Access Compliance Report Public Rights-of-Way (Curb Ramps)

Main Street: TOPAZ_ST Cross Street: MEDANO_ST Location: NW

ADA ID: RPRK211124135605 Ramp Type: Type 4 - Parallel Initial Pass/Fail: Fail Overall Compliance: No Severity Score: 2

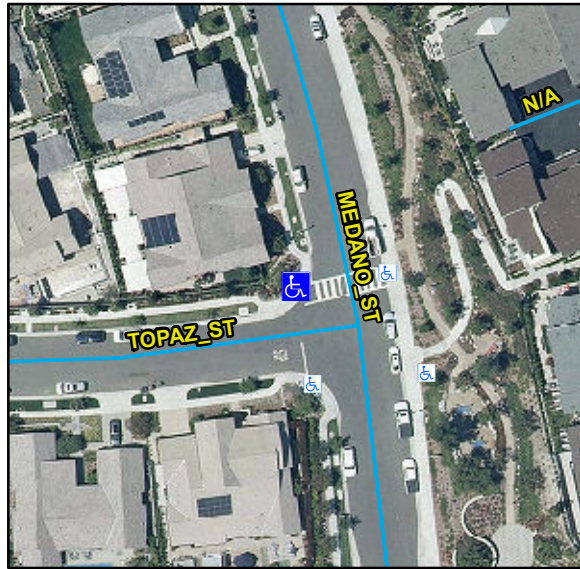
Compliance	Description	Data	Compliance	Description	Data
N/A	Ramp Length LT (in)	111	N/A	Ramp Length RT (in)	110
Yes	Ramp Width LT (in)	60	Yes	Ramp Width RT (in)	60
Yes	Ramp Run Slope LT (%)	5.9	Yes	Ramp Run Slope RT (%)	2.8
No	Ramp Cross Slope LT (%)	2.6	Yes	Ramp Cross Slope RT (%)	0.8
N/A	Landing Present	N/A	N/A	DWS Provided	N/A
N/A	Landing Length (in)	N/A	N/A	DWS Contrast	N/A
N/A	Landing Width (in)	N/A	N/A	DWS Length (in)	N/A
N/A	Landing Run Slope (%)	N/A	N/A	DWS Full Width	N/A
N/A	Landing Cross Slope (%)	N/A		DWS Offset Type	N/A
N/A	Landing Movement Obstructed?	N/A	N/A	DWS Offset Left (in)	N/A
	Landing Movement Type	N/A	N/A	DWS Offset Right (in)	N/A
N/A	Landing Shared	N/A			
N/A	Clear Space	Yes			
N/A	Clear Space To Crosswalk (in)	N/A			
N/A	Marked Crosswalk 1	No	N/A	Marked Crosswalk 2	Yes
	Crossing 1 Direction	S		Crossing 2 Direction	E
	Marked Crosswalk 1 Width (in)	N/A		Marked Crosswalk 2 Width (in)	144

Remove & Replace Curb Ramp With Two New Directional Ramps or Equivalent.
